Contingency Allowance Expenditure Authorization

Project: HIDALGO COUNTY EL PARAISO HEALTH CLINIC & COMMUNITY RESOURCE CENTER

Authorization No. 01

Change Proposal Request	
Contract #	001
CPR #	001 R5
Issue Date	16-Oct-2024
Subject	ASI 001 Changes to Asphalt Drive

Sheet L109

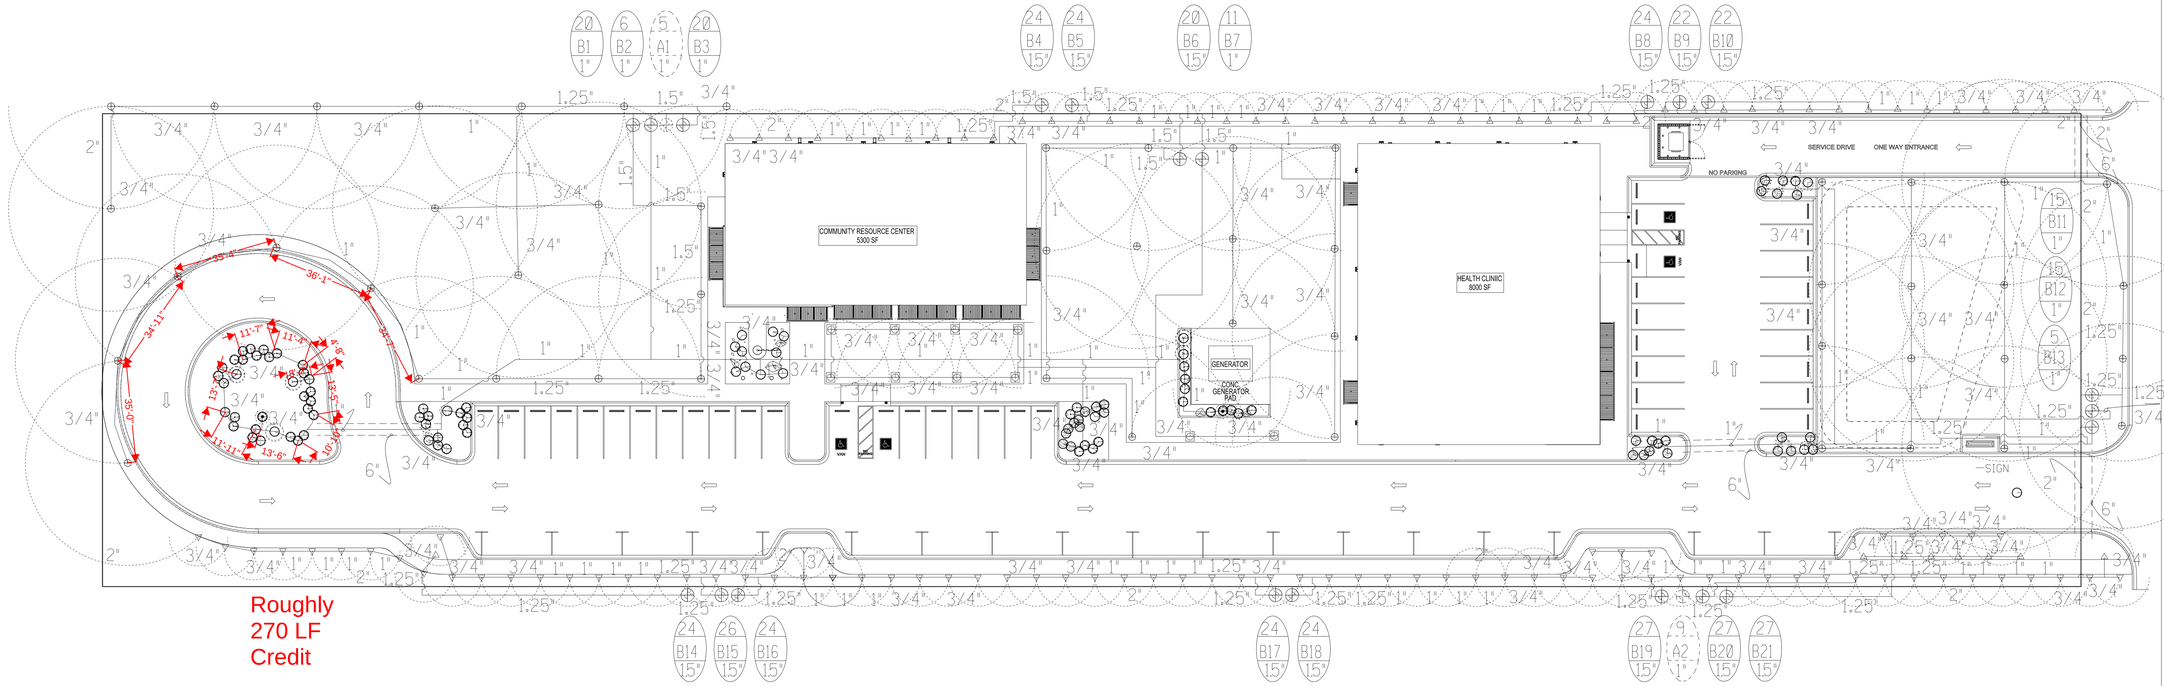
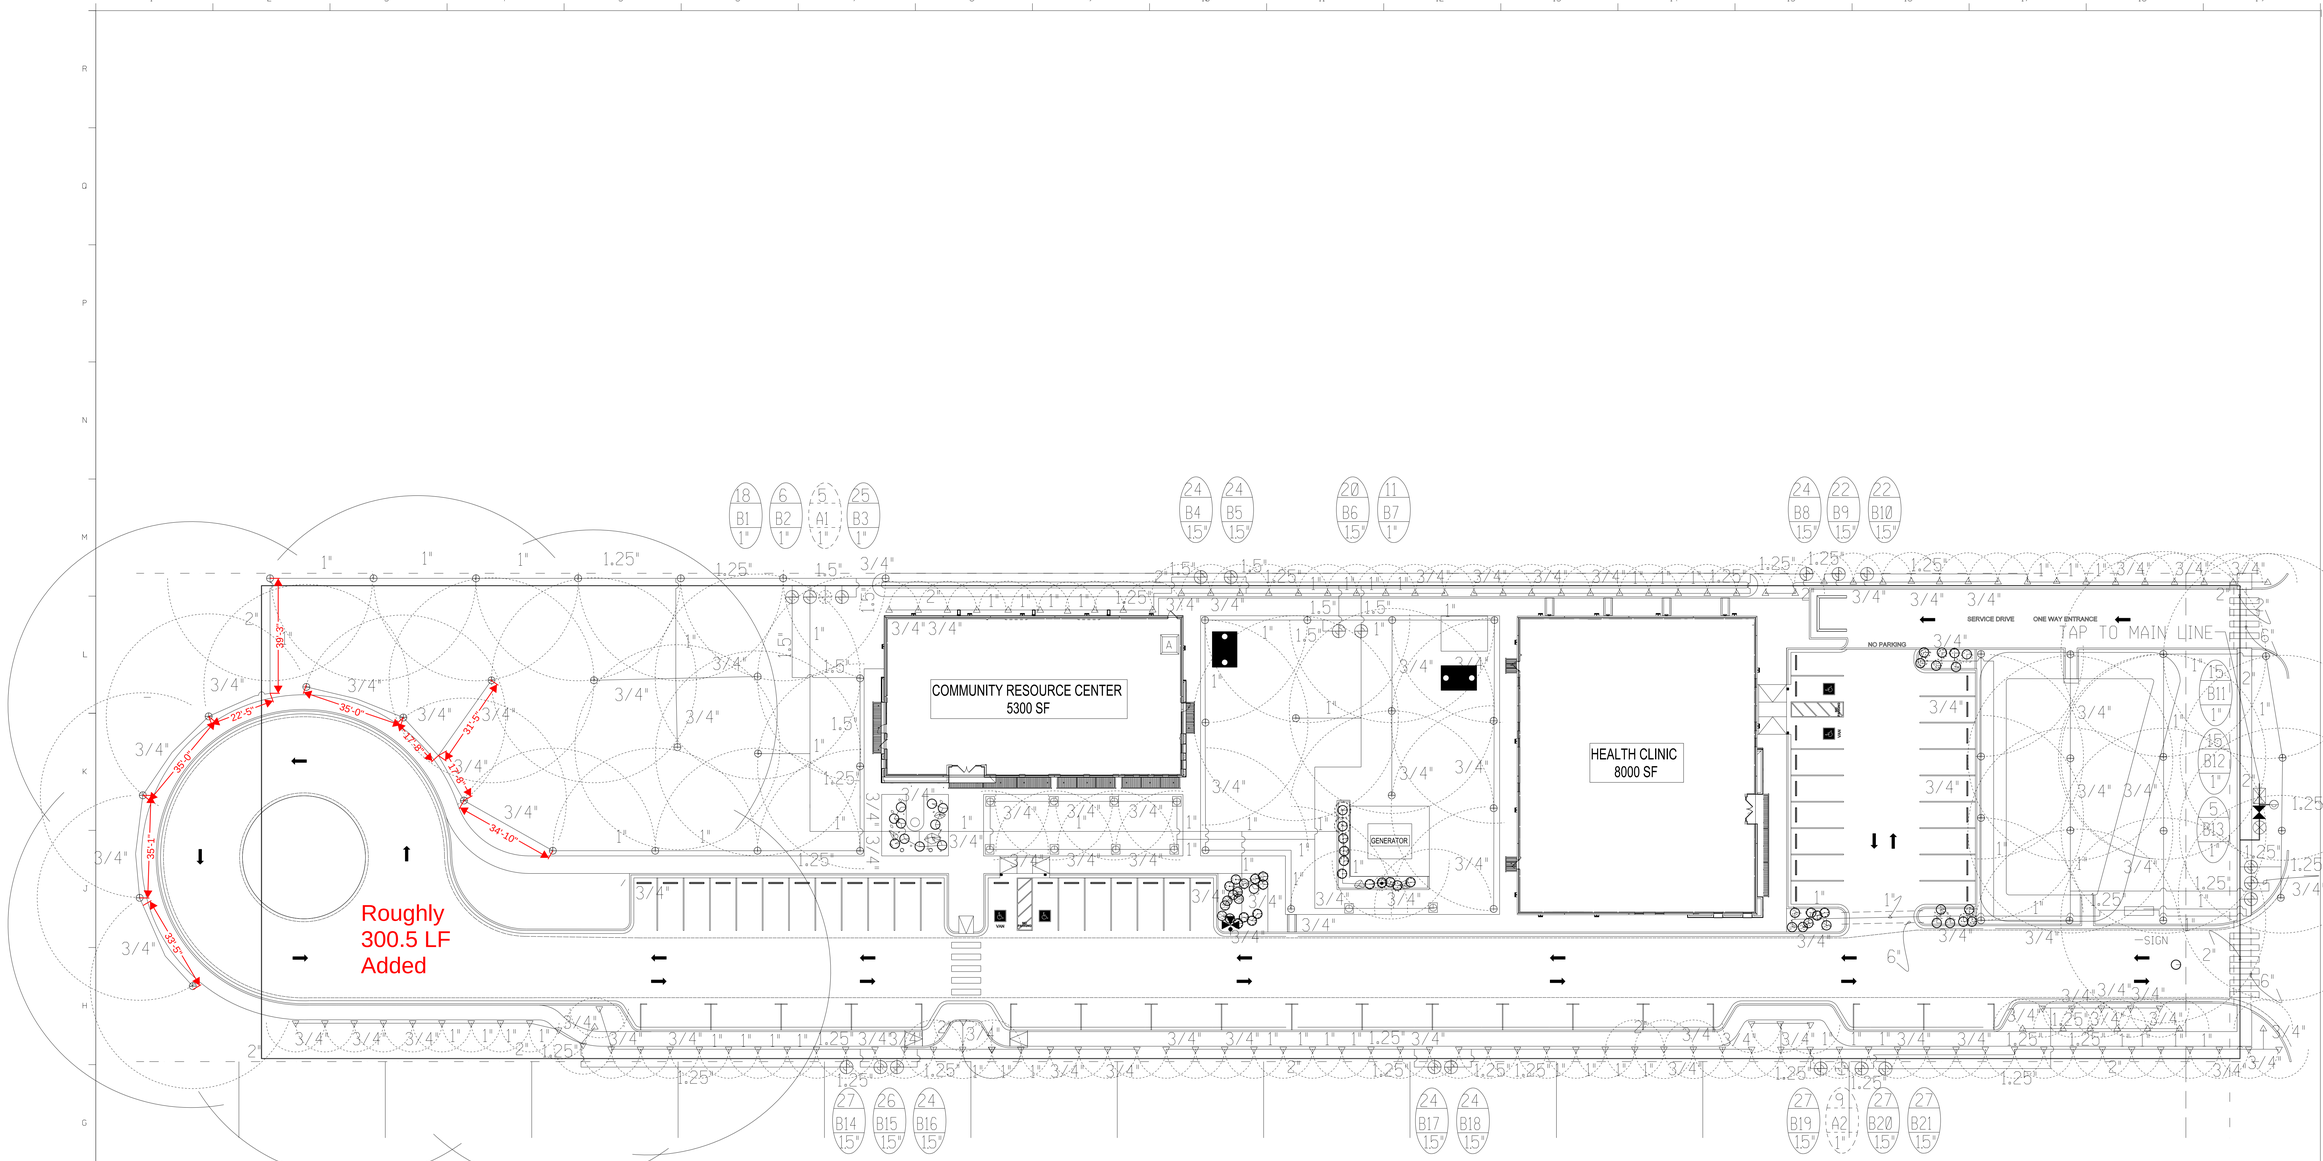
Roughly
270 LF
Credit

Added roughly 130 LF of Dripline to Trees & Shrub
